**REQUEST FOR BID  
 BID NUMBER 220807**

**ADDENDUM NO. 4**

Date: August 18, 2022  
 Re: FORKS SUBSTATION TRANSFORMER  
 To: ALL PROSPECTIVE BIDDERS

**3. RATING**

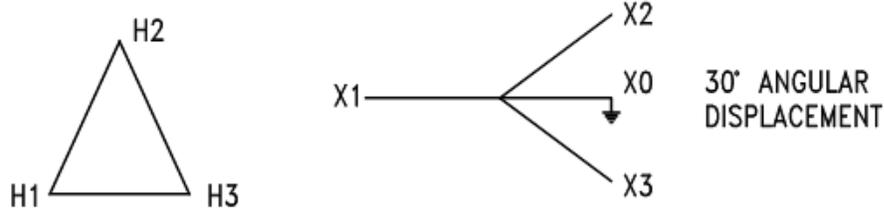
- 1.) In SECTION III- Specification, paragraph 3, seen in customer specs below, the unit is ONAN/ONAF/ONAF and from paragraph 2, the temp rise is 55°C. However, the hot spot 80°C is normally for 65°C rise. Please confirm the temp rise – 55 or 65. Also the rating is not per ANSI. Per ANSI these ratings will be 10/13.3/16.67. What is the max KVA that you need?

**Basic ratings should be based on 55°C rise.  
 We didn't set a maximum KVA needed, we're targeting a minimum 10MVA.**
